BULLETIN # B-97-2009-S

**Product: Garland Convection Oven
Subject: New Axial Cooling Fan**

Instructions for Convection Oven Axial Fan Replacement

Original Axial Fan – PN 1918201/1918202

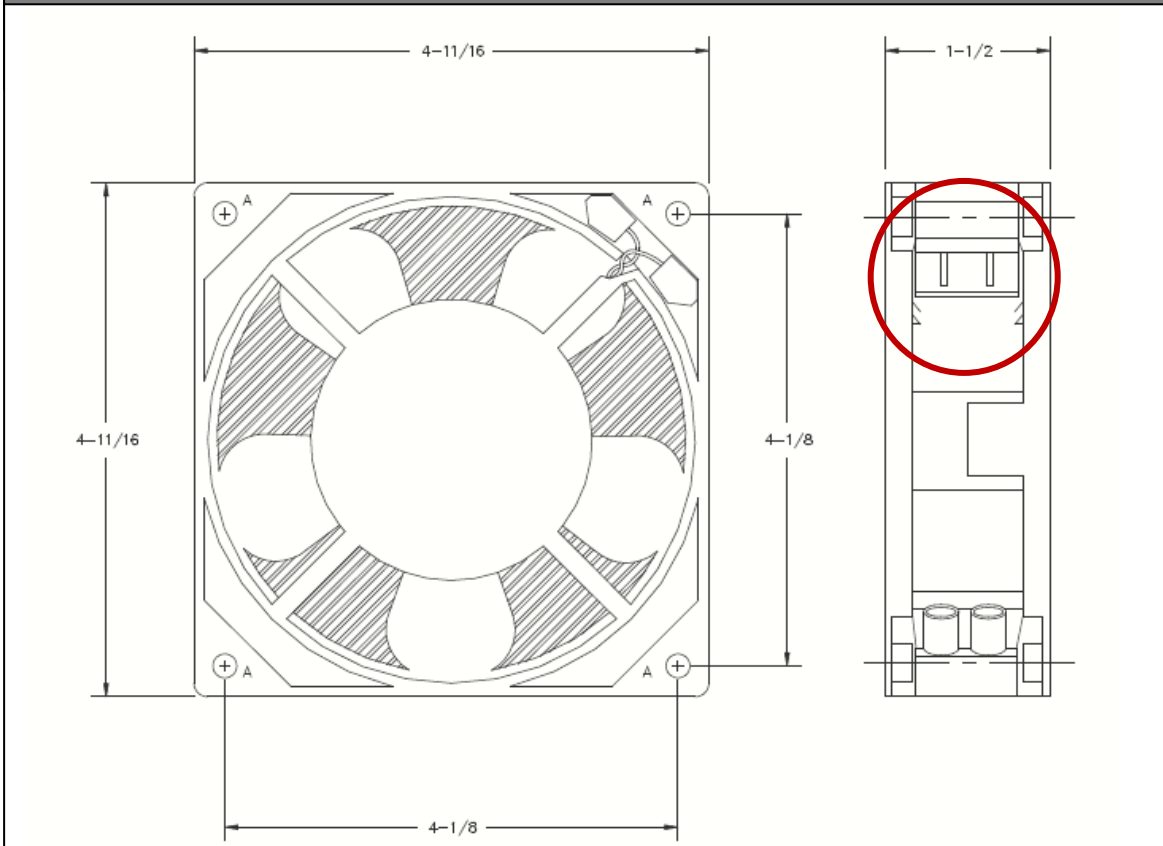
Original fan part numbers 1918201 and 1918202 have been replaced by part numbers 1671100 and 1671101 respectively.

(Key difference – the Terminals are on opposing sides)

When installing the 1671100/1 fan, note the design of the surrounding duct. If the opening across the full width as shown in photo 1, orient the fan as shown for optimal wire routing. If the duct is only open 50% as in photo 2, orient the fan as shown below in photo 3. When the duct is reinstated, route the wires as shown in photo 2. (Ensure the wires are not pinched or damaged when installing the duct.)
